IMPORTANT SAFETY NOTICE

NHTSA CAMPAIGN NUMBER 07C006

September 2007

INCORRECT ROUTING FOR REAR-FACING MODE

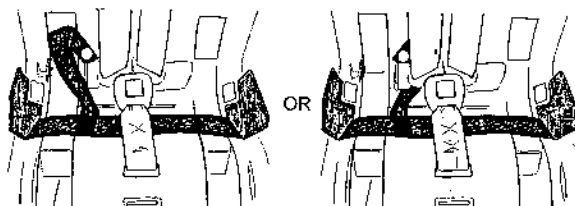
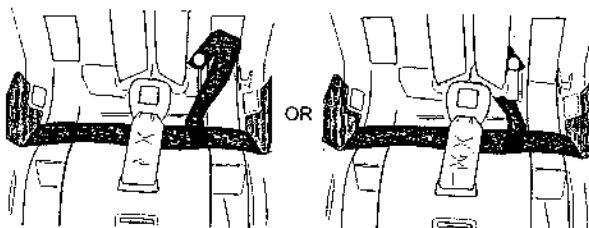
On some of these child restraints, the Lower Anchorage belt was misrouted under the shoulder portion of the harness during assembly, instead of under the crotch belt/buckle section of the harness. If the child restraint is installed in the rear-facing mode and the Lower Anchorage belt is attached to the vehicle's LATCH anchor, the seat back angle of the child restraint can exceed 70 degrees in a frontal crash. This increased rotation may increase the risk of injury to the child.

Remove the seat pad and refer to the following pictures which show incorrectly routed and correctly routed Lower Anchorage belts. If your child restraint has an incorrectly routed Lower Anchorage belt (with the belt routed behind the shoulder portion of the harness), reroute the Lower Anchorage belt as described in Step 3. If the routing is already correct, reinstall the seat pad making sure you reattach using all the connections. Please refer to your ComfortSport Instruction Manual to reinstall your child restraint in your vehicle. If you do not have an Instruction Manual, go to www.gracobaby.com or call 1-800-345-4109.

Remove the Lower Anchorage belt from behind the harness straps and place it under the crotch strap portion of the harness as shown above, keeping the belt flat and tight against the child restraint so that it does not interfere with the harness system. The lanyard attaching the Lower Anchorage belt may be on either the right or left sides of the harness. Depending on which way your lanyard is mounted, assemble as shown above.
